Service Bulletin

Bulletin No.: 16-NA-170

Subject: Brake Pulsation, Rattle While Driving and/or Vibration During Brake Apply

Brand:	Model:	Model Year:		VIN:		Engine:	Transmission:
		from	to	from	to		
Chevrolet	Corvette	2014	2016			All	All

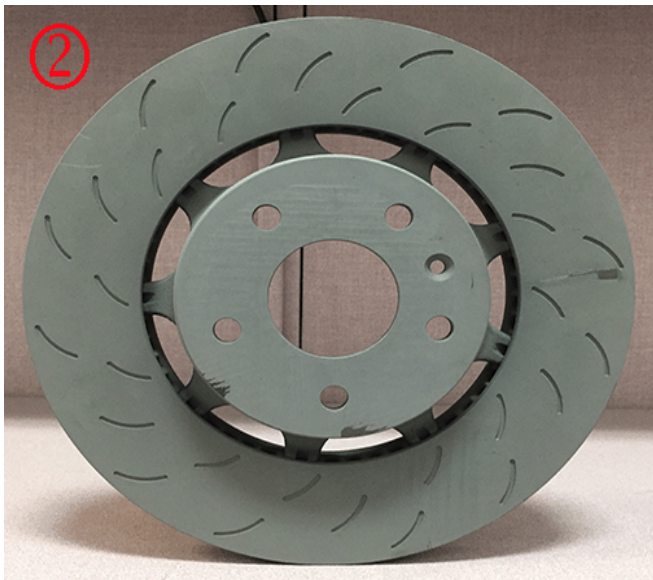
- For front rotors and vehicles built prior to May 31, 2016, replace old two piece design (2) with new one piece design (1).
- For rear rotors and vehicles built prior to July 23, 2015, replace old two piece design (2) with new one piece design (1).

Important: The rotors **MUST** be replaced as a pair due to a design change.
